Handling loss of signal in the ILT/RTS functions

(addressing comment #I-109)

Figure 178B-10a—Training control state diagram, part 1

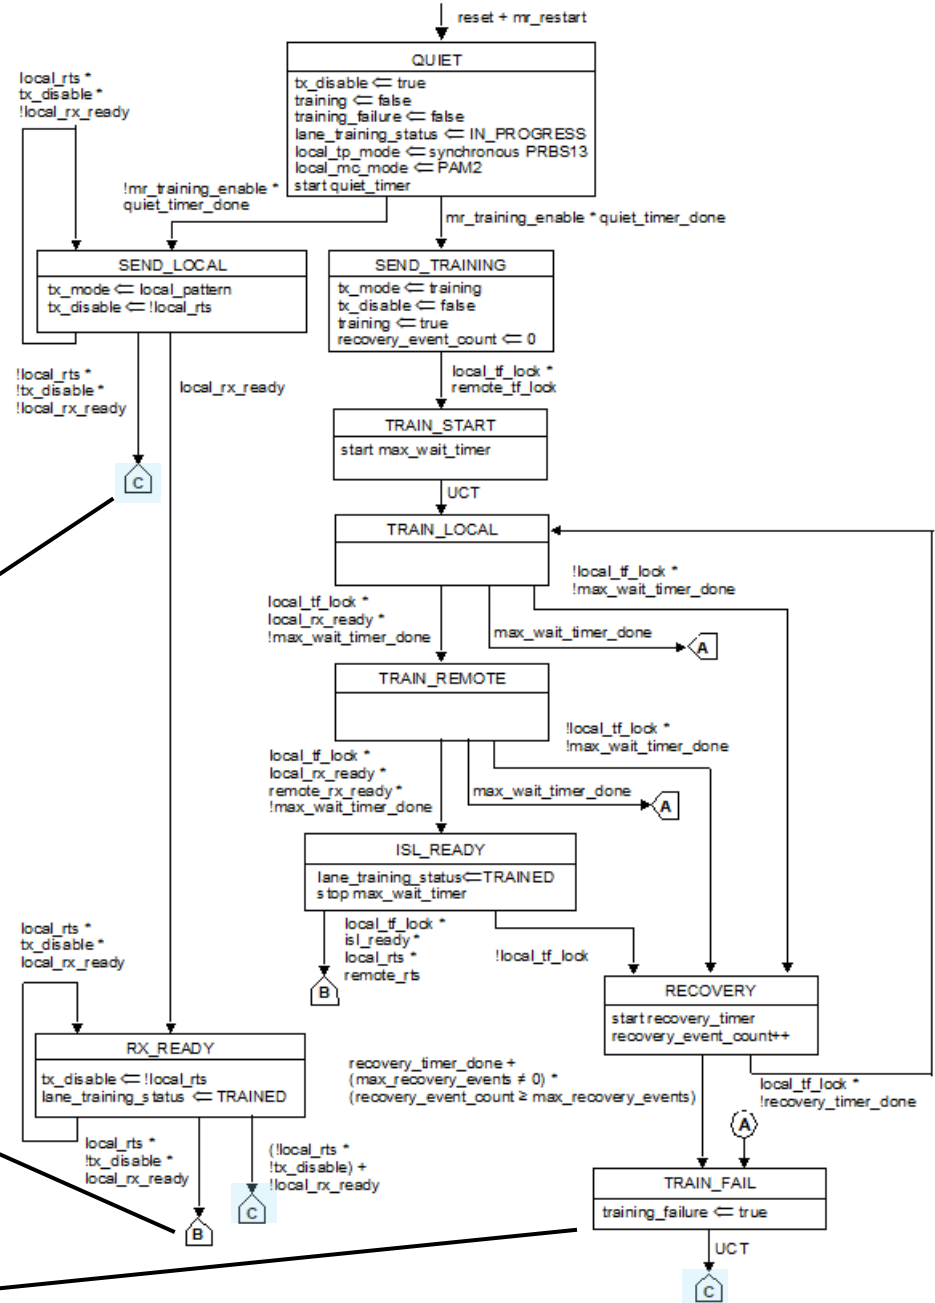
Minor changes in this part:

“C” pointers go to a new state ISL_FAIL (separate from training)

“B” pointers go to the existing PATH_READY

FAIL state split into two; TRAIN_FAIL only applies when mr_training_enable=true, then goes to ISL_FAIL

Figure 178B-10b—Training control state diagram, part 2

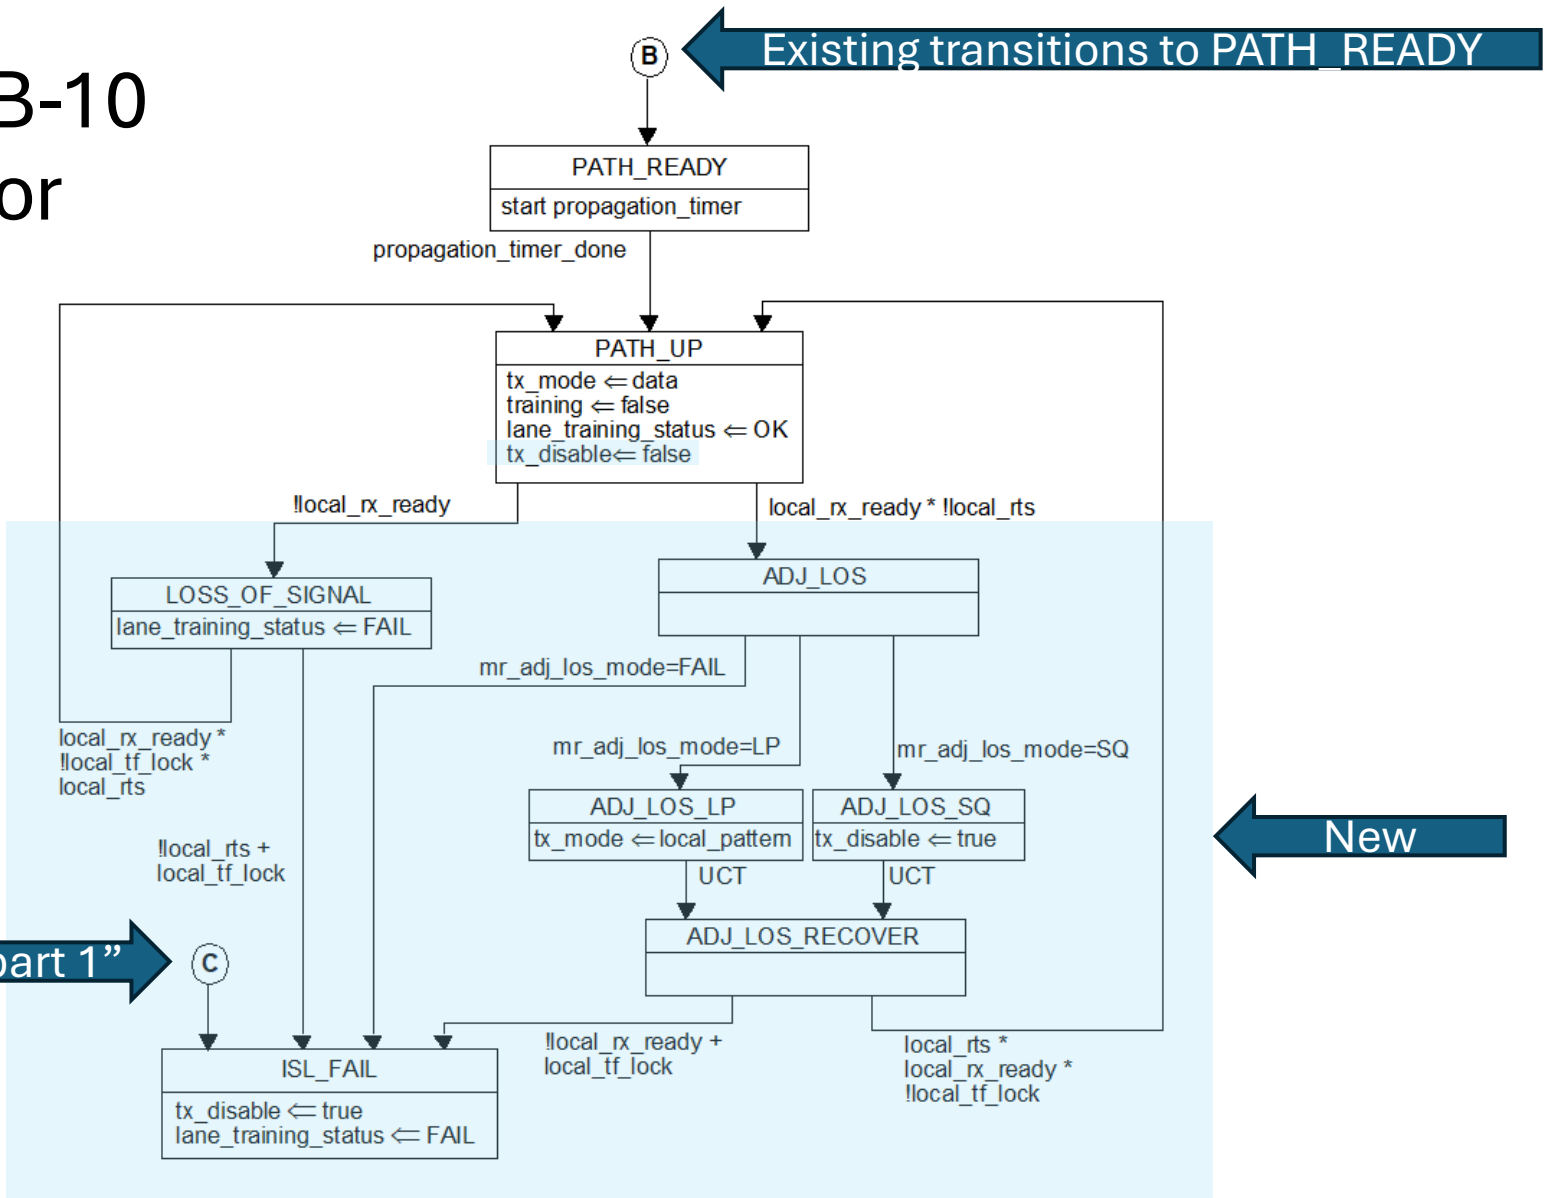
Additions to Figure 178B-10 to enable either restart or recovery from LOS (using squelch or replacement signal on adjacent interface)

“Option Y”

Transitions from “part 1”

addition to Figure 178B-10

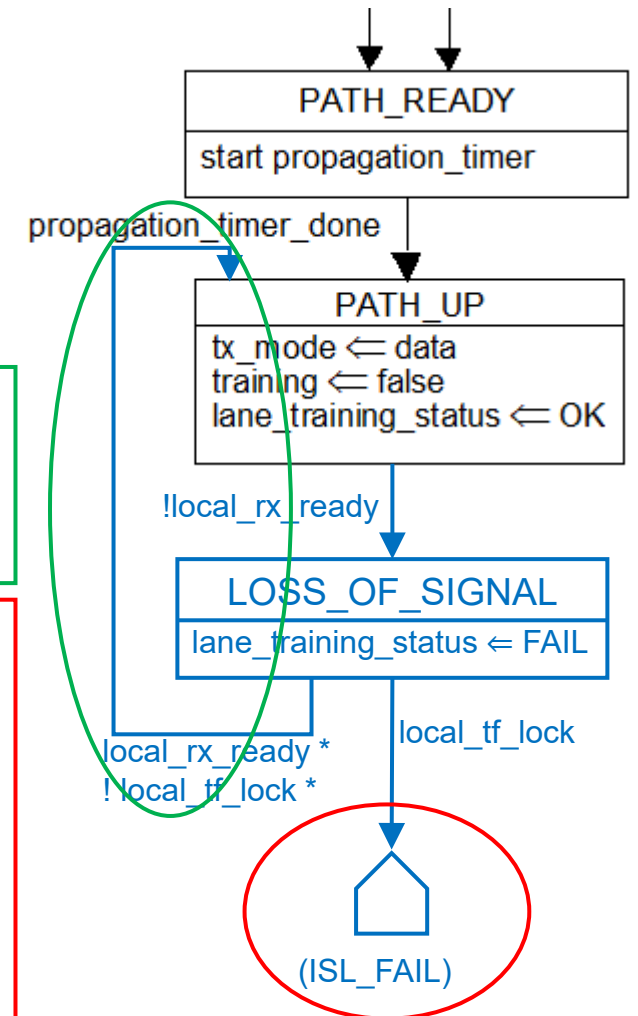
LOS at the input of this interface

- LOS needs to be communicated to the adjacent interface to enable auto-squelch.
- In PATH_UP, when loss of signal event is detected, transition to a **new state LOSS_OF_SIGNAL**.
- In this state:
 - lane_training_status becomes FAIL
 - This is communicated to the adjacent interface via SIGNAL_OK
 - The output of this interface is not squelched, to enable Remote Fault signaling to be used (it is squelched only if ISL_FAIL is reached).

Recovery from LOS at the input of this interface

- Signal re-appearing is indicated by local_rx_ready
 - The timing and conditions to declare local_rx_ready is not specific It should indicate “good data”.
- If the signal is not training frames (PAM4, mission data):
 - Return to PATH_UP
 - lane_training_status=OK propagates through service interface
- If it is training frames (PAM2):
 - This means positively that the peer has restarted training
 - We must restart training too (no other way to recover)
 - Transition to ISL_FAIL, which requires mr_restart to exit
 - Note: indicated in the diagram as local_tf_lock, but could be detected by other means, e.g. not detecting AMs in the PMA/PCS.
- Management can always restart training (mr_restart)
 - For example, if the signal does not re-appear within some time

Figure 178B-9—RTS update state diagram

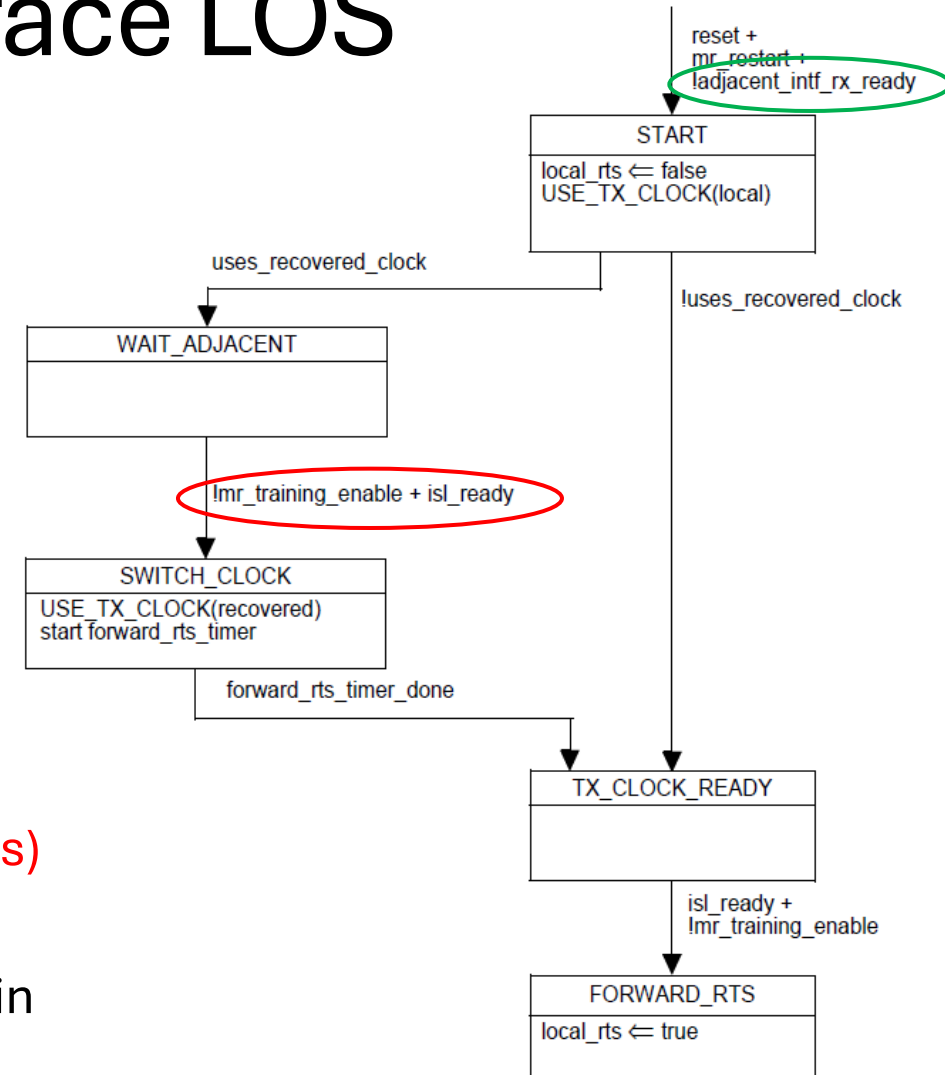
Recovery from adjacent interface LOS

- When SIGNAL_OK on the service interface (from the adjacent interface) recovers to OK...
 - **adjacent_intf_rx_ready becomes true**
 - The RTS update state diagram advances from START
- The state diagram needs to set local_rts=true to make the local interface unsquelch ([slide 20](#)).
- If **mr_training_enable=false**, the transition is unconditional.
- But if **mr_training_enable=true**:
 - If a recovered clock is used (module/retimer) it needs **isl_ready (local_rx_ready * remote_rx_ready on all lanes)** to advance to SWITCH_CLOCK
 - In data mode, training frames are not received, so **remote_rx_ready** is irrelevant. It should be set to true in its definition.
